TRANS/WP.29/GRSG/2003/9
21 February 2003

PROPOSAL FOR DRAFT AMENDMENTS TO REGULATION No. 46

(Rear view mirrors)

Transmitted by the expert from Germany

Re. Paragraph 15.2.4.3.1.

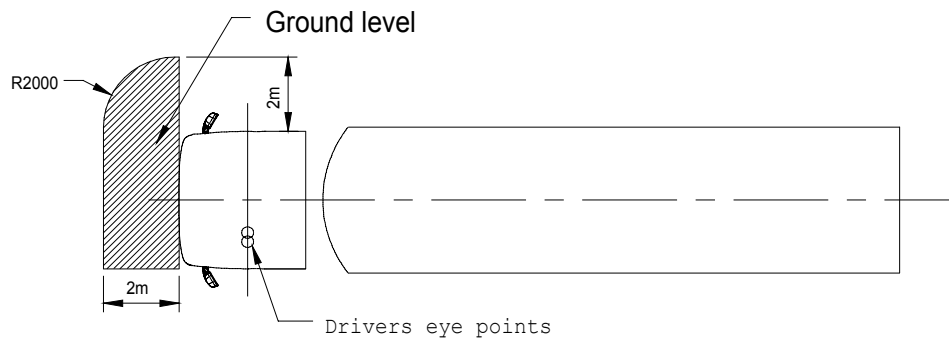
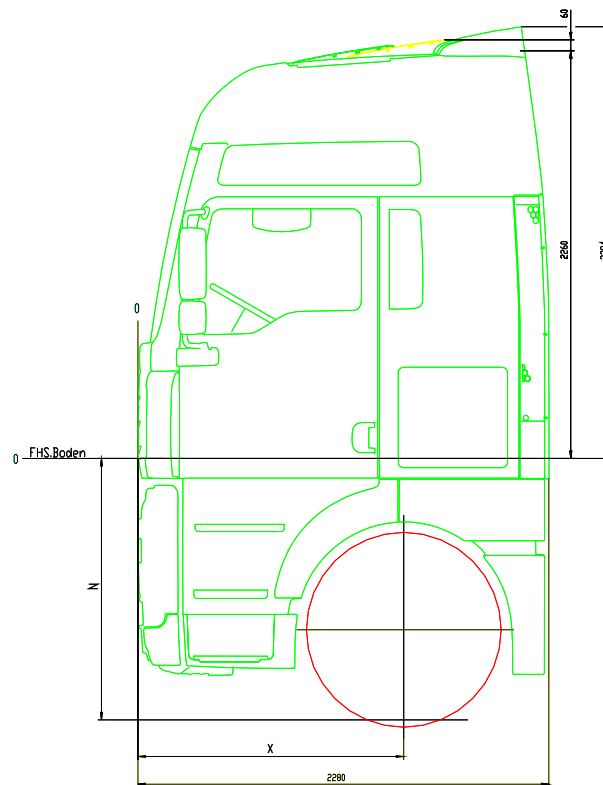
In addition, ~~the road must be visible to~~ **it shall be possible to** the driver **to detect an object with a diameter of 30 cm and a height of 50 cm within an area of 1 m width** ~~over a width of 1 m, which~~ which is bounded by a plane parallel to the median

The intension of this adaptation to technical progress should be to increase the angle of view for the driver to detect objects also adjacent to the side of the vehicle so that the "dead angle" is decreased or avoided. The vision of the road surface is not necessary because even very small children have a standing height of at least 50 cm and the usual sitting height in a M1- vehicle is so that the driver can see those objects directly. The introduction of aspherical mirrors would be a better solution for giving the driver a better angle of view. The requirement as given in the proposal would only increase the height of the mirror (glass and housing) but not the width. Without any reason the required width of the class III mirror on the drivers side was reduced to 4m (20m behind the eyepoints) instead of 5 m (corresponds to 2,5 m,10 m behind the eyepoints).
